MYO FINAL MONITORING REPORT

LAUREL SPRINGS STREAM AND WETLAND MITIGATION SITE

DMS Project No. 100122

Response to DMS Comments

Figure 1 – Location of shed within the Site's conservation easement

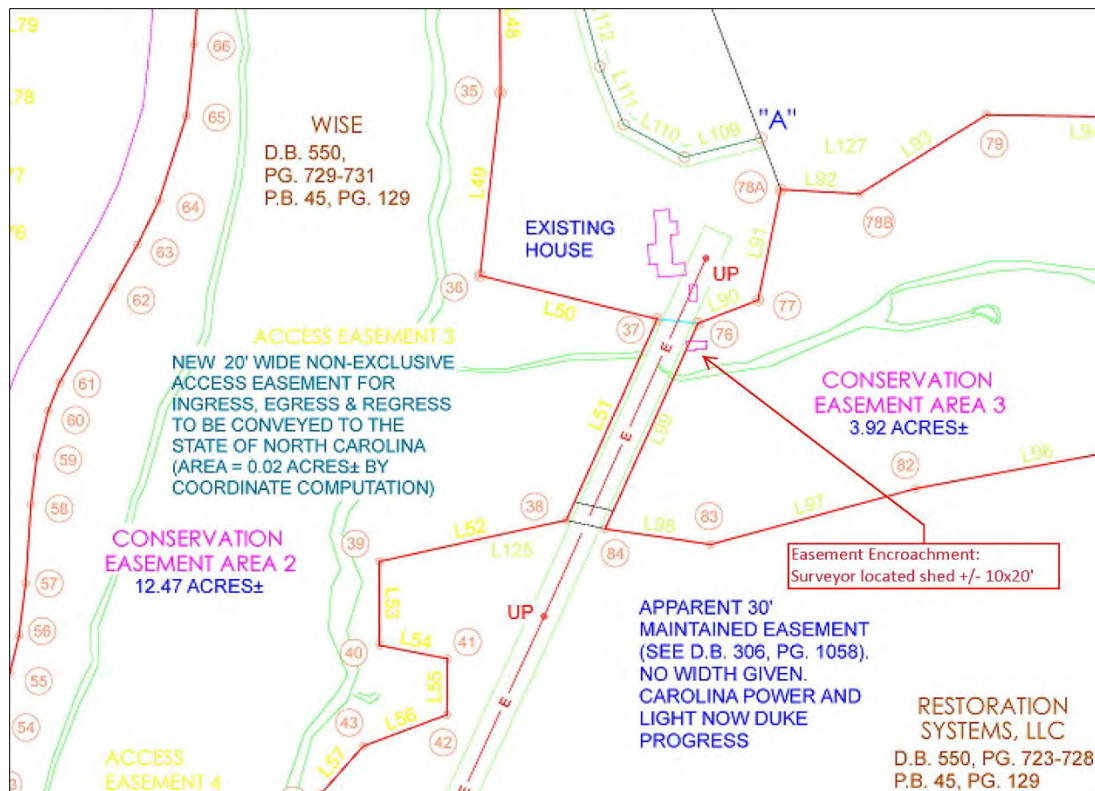
During the MY0 site visit with the NCDMS, it was noted that a small (approximately 10'x20') shed was located within the easement and UT3. Through discussions with DMS and the landowner, it was agreed the best course of action was to decommission and remove the shed as opposed to modifying the conservation easement. RS has offered, and the landowner has agreed, to construct a new shed, outside of the easement boundary, and to remove the old shed and equipment from the easement. This work is being schedule and will be completed before the final Year 1 Monitoring Report.
